SUBJECT:

Site Inspection, Cane Creek Mine, Moab Salt, LLC, M/019/005,

Grand County, Utah

The Division is reviewing a revised reclamation plan, and I wanted to look at some of the drill sites, the tailings pond, the proposed landfill, and one of the cutoff dams.

Photo 1. One of the reclaimed wells. In this picture and in Photo 2, note the salt crust near the hole and the encroaching vegetation, even on very shallow soils.

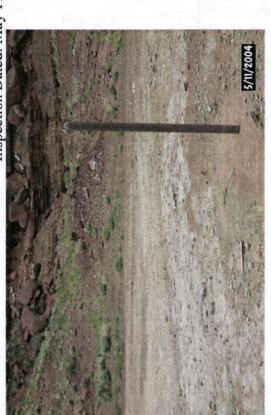
We visited about five well sites, and three are shown in Photos 1 through 3. At all but one of these sites, there was a salt crust in an area within about 15-20 feet of the well. Outside this circle, there were thin layers of soil with some vegetation consisting of mostly shadscale and Indian ricegrass. This soil appears to have been eroded in to these areas.

It is not certain exactly how far from the reclaimed wells the surface salt contamination extends and whether it is under the thin soil layers that have accumulated. I believe it is under this soil, and, if so, remediation of the salt contamination may be much easier than previously thought. The plan the Division is currently reviewing says salt-contaminated soils will be dug up and disposed of in the landfill, and replacement soil will be brought in.

I recommend that the operator try placing a few inches of soil over some salt-contaminated soil, leaving the surface rough without disturbing the salty soil, seeding it, and watching to see what can grow and survive. Some testing of the soil might also be useful to see how deeply any contamination extends.

Photo 5. Panorama of an area that will be proposed as a landfill. The area that would be used is against the feature just above the center and toward the right of the photo.

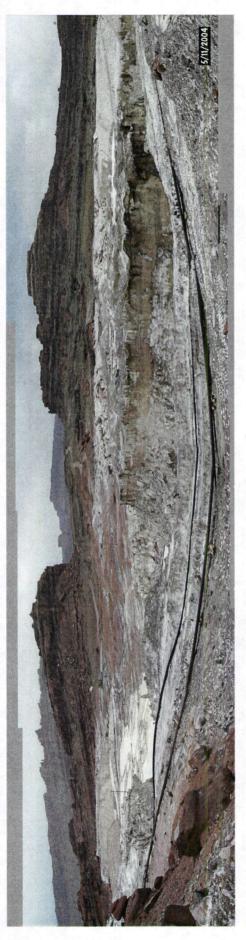
Mr. Klein said the operator is working to change the plan for the landfill. The plan currently being reviewed by the Division shows demolition waste and some other material being disposed of in a canyon on the southeast side of the tailings pond. Mr. Klein showed me another area (Photo 5) with better access that is now being considered both as an area for disposal of demolition debris, and to dispose of some waste from the operation.

Soils in a large portion of the proposed landfill have been affected by salts from the tailings pond. These soils should be rinsed before being used for revegetation.

It was difficult to tell how much soil would be available for reclamation in the area we examined. The upper portion of the area, the right side of Photo 5, has not been affected by the salt tailings pond, and there could be up to several feet of soil in this area. Other areas are covered by bedrock while others have intermediate quantities that could be saved. For the landfill in the proposal before the Division, the operator has estimated about two feet of soil could be placed over the landfill. There is probably about this same amount in the new area.

At the time of the inspection, I did not realize or express some of the concerns the Division might have about the new landfill site. It is a relatively open area that could be seen from many nearby areas, but the canyon landfill would be more secluded. In the new area, debris would need to be pushed against Page 3 of 3 M/019/005

the hill and covered with soil, and there would probably be increased potential for erosion and exposing the trash. The operator might consider a landfill for the operations phase and keeping the canyon landfill for reclamation when access is likely to be easier.
